STAFF REPORT
COMMUNITY DEVELOPMENT DEPARTMENT

HEARING DATE: October 7, 2021
 TO: Planning & Zoning Commission
 FROM: Alan Tiefenbach, Associate Planner
 208-884-5533
 Bruce Freckleton, Development Services Manager
 208-887-2211
 SUBJECT: H-2021-0042
 Intermountain Wood Products Expansion
 LOCATION: The properties are located at 255, 335, 381, and 385 S. Locust Grove Rd, and 220, 300 and 330 S. Adkins Way, in the NE ¼ of the NE ¼ of Section 18, Township 3N, Range 1E.

This is a request to expand an existing wood products business by annexing 3.1 acres of property with the I-L zoning district, and modifying the Medimont Development Agreement to create a new development agreement to remove a requirement for an internal landscape buffer. This application includes requests for two Comprehensive Plan Map Amendments. The first amendment is to change the designation of the properties to be annexed from mixed use community to industrial to allow zoning to I-L for the warehouse. The second map amendment involves the two properties to the south at 381 and 385 S. Locust Grove Rd (not part of the development) being designated from mixed use community to commercial to make them more consistent

D. Site Plan (date: 1/12/2021) **NOT APPROVED**

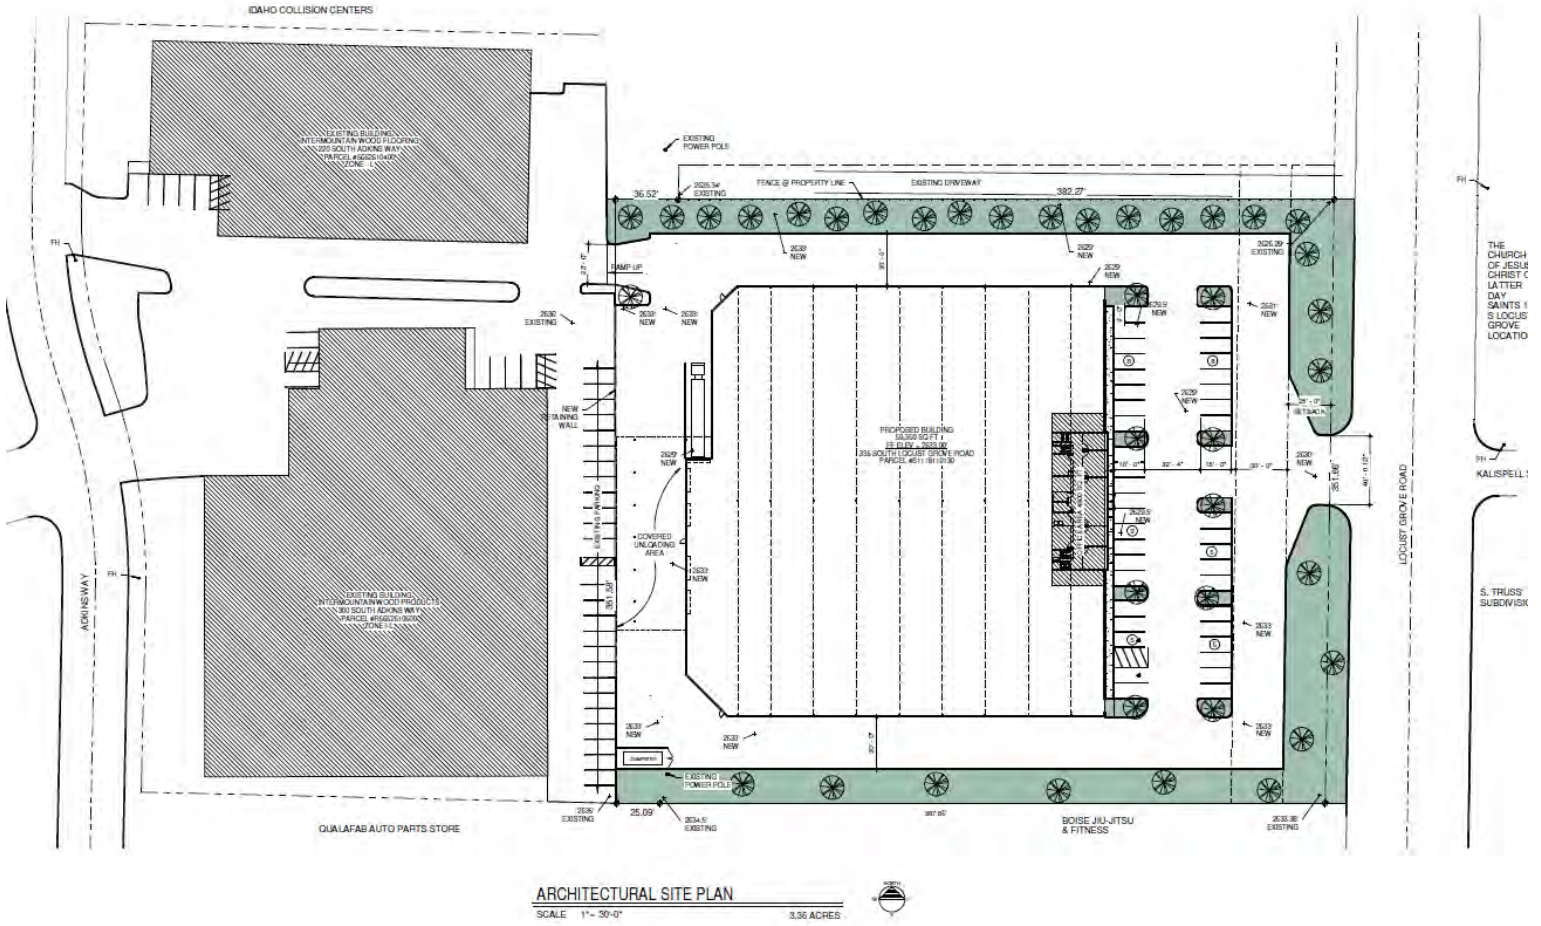
Staff does have concerns regarding the present concept plan as will be discussed in the dimensional standards section below. Staff has red-marked on the concept plan that this plan should not be approved and future development should comply with all pertinent regulations and the Architectural Standards Manual.

The concept plan indicates primary access, including for trucks, occurring directly from S. Locust Grove, an arterial. Also, staff has recommended to the applicant that cross access be provided to the properties to the north and south, although the concept plan does not reflect this. Staff has addressed this in the conditions of approval. Existing Structures/Site Improvements:

The site and design standards of UDC 11-3A-19 state that for properties greater than two (2) acres in size, no more than fifty (50) percent of the total off street parking area for the site shall be located between building facades and abutting streets. The concept site plan as submitted shows the entirety of the parking between the building and S. Locust Grove Rd.

UDC 11-3A-19 also requires an applicant to extend or improve streets, drive aisles, cross access easements or similar vehicular and pedestrian connections provided from adjacent properties. The concept plan as submitted does not provide access to the properties to the north and the south. As a condition of approval of the development agreement, staff is recommending cross access to these adjacent properties.

Staff does have concerns with the concept site plan as submitted because of the comments listed above. Staff has additional concerns regarding the size and visibility of the proposed warehouse as would be viewed from S. Locust Grove Rd., and is unsure the building as shown would meet all the requirements of the Architectural Standards Manual (ASM). Although staff is overall supportive of annexation of the property for the purpose of the expansion, staff believes additional revisions need to be made to the site plan in order to be consistent with the regulations. Staff is not supportive of the concept plan as submitted.

S. Locust Grove Road is classified as an arterial roadway and is improved with 5-travel lanes, bike lanes, vertical curb, gutter, and 7-foot wide sidewalk abutting the site. The concept plan as submitted shows access for this site occurring via a 40 ft. driveway directly from S. Locust Grove Rd. The applicant has mentioned employee, customer and truck access could occur at this driveway. ACHD has noted this proposal complies with all ACHD requirements. The Council can grant a waiver to allow the access, but staff prefers the applicant develop the site plan with internal circulation and send trucks through S. Adkins Way as previously discussed at the pre-application meetings.

Staff has concerns with access occurring from S. Locust Grove Rd. UDC 11-3A-3 states where access to a local street is available, the applicant shall reconfigure the site circulation plan to take access from such local street. Also, where access to a local street is not available, the property owner shall be required to grant cross-access/ingress-egress and extend or improve streets, drive aisles, cross access easements or similar vehicular and pedestrian connections provided to adjacent properties.

During the March 2021 Pre-Application meeting, it was mentioned to the applicant that the site plan as submitted should be revised to remove primary access from S. Locust Grove, access should be provided to the properties to the north and south, and it would be preferable for truck access to occur via the existing driveway from S. Adkins Way. The concept plan as submitted does not reflect any of these access points. As a condition of approval, staff recommends the access from S. Locust Grove Rd be closed, and the site plan be revised to indicate access from the north, south and west.

UDC 11-3C-6 requires one space for every 2,000 sq. ft. of gross floor area for industrial uses (warehouse). Based on a 53,350 sq. ft. warehouse and 4,800 sq. ft. of office space this amounts to 27 parking spaces required whereas 44 are provided. However, as mentioned above in the dimensional standards section above, the parking configuration as shown on the site plan does not comply with UDC 11-3A-19 in that all parking area is located between building facades and abutting streets.

11-3C-5 requires all off street parking areas to be provided with a substantial wheel restraint to prevent cars from encroaching upon abutting private and public property or overhanging beyond the designated parking stall dimensions. When a bumper overhangs onto a sidewalk or landscape area, the parking stall dimensions may be reduced two (2) feet in length if two (2) feet is added to the width of the sidewalk or landscaped area planted in ground cover. The concept plan does not appear to meet either of these requirements.

- b. The S. Locust Grove Rd. access shall be used for emergency access only, unless waived by City Council in accord with UDC 11-3A-3.
- c. Cross-access easements shall be granted to the abutting property to the north (Parcel # S1118110071) and south (Parcels # R0879824125 and R0879824130); a copy of the recorded easement shall be submitted to the Planning Division with the Certificate of Zoning Compliance application for this site.

- f. The applicant shall comply with the warehouse specific use standards set forth in UDC 11-4-3-42. The proposed outdoor loading area shall not be located closer than 300 feet from the adjacent residential property to the north or fully enclosed.

- g. A 25-foot wide landscape buffer shall be constructed on the northern boundary to residential land use as required per UDC Table 11-2C-3, landscaped per the standards listed in UDC 11-3B-9C, unless otherwise reduced by City Council.
